RE: MAHONING COUNTY  
CRAB CREEK BASIN  
CITY OF YOUNGSTOWN  
WATTS INDOOR FACILITY

On July 15, 2010, Ohio EPA conducted an inspection of the Watts Indoor Facility project, located along the eastbound service road between Elm Street and Wick Avenue, City of Youngstown, Mahoning County (site). Ohio EPA records indicate that the site is covered by the General National Pollutant Discharge Elimination System (NPDES) Permit for Storm Water Associated with Construction Activity (General Storm Water Permit), permit No. 3GC04792\*AG. The inspection documented the following:

Figure 4. Silt fence was observed to be damaged.

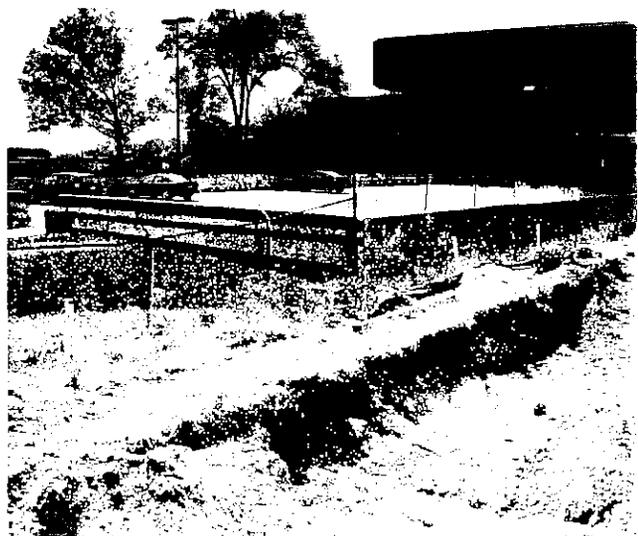
- No inlet protection has been installed at the curb inlets along the eastbound service road between Elm Street and Wick Avenue (Figure 1). Install inlet protection in accordance with the site's storm water pollution prevention plan (SWP3).
- Heavy offsite tracking of sediment was observed (Figure 2). Minimize the offsite tracking of sediment through scraping or sweeping. It may be necessary to reinstall the construction entrance.
- Dust control appears to be a major issue on-site (Figure 3). Minimize dust generation through watering activities and street sweeping.
- Silt fence has been damaged (Figure 4). Repair or reinstall silt fence in accordance with the site's SWP3.
